## Tusten Multigenerational Park Pavilion Committee Meeting Summary

Prepared by Jill Fruchter, August 16, 2023

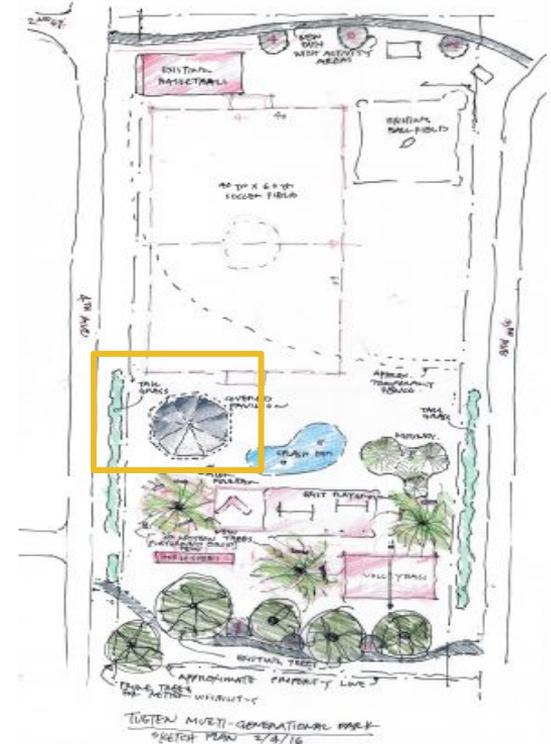
- The original dimensions proposed (30' x 50') was considered TOO BIG by most. The exception was the Tusten Youth commission which wanted an even bigger footprint to accommodate ongoing growth.
- A general consensus surfaced around various references such as “smaller than Minisink,” what could comfortably fit 6 picnic tables with room for circulation, or 20' x 24' was suggested. (See next slide for diagram)

- As in the original sketch plan (see right), a North/South orientation adjacent to 4th Avenue seemed acceptable to most, citing sight lines to both playground and ballfield, shade optimization, and safety provided by existing lighting.

# Diagram for size (recommended by resident)

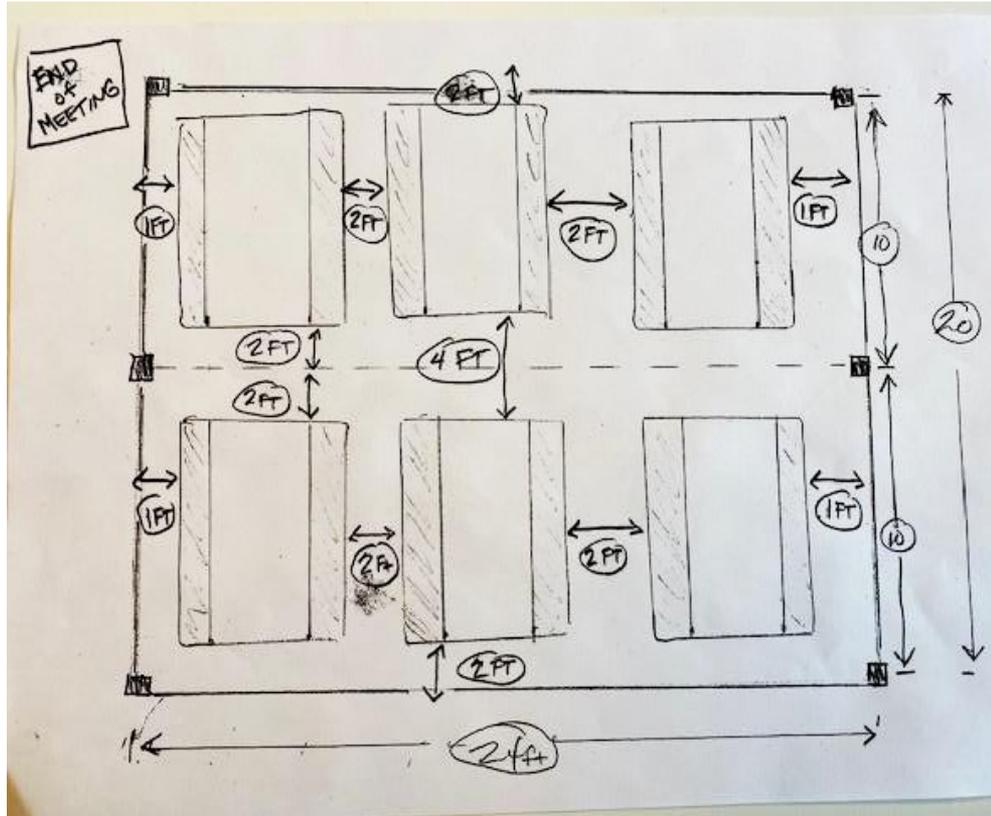
- **[SIZE]** With the exception of the Tusten Youth Commission who advocates for a larger footprint to accommodate 50+ individuals, most advocated for a smaller footprint at 20’ x 24’ (big enough to fit 6 picnic tables). (See *slide 14*).
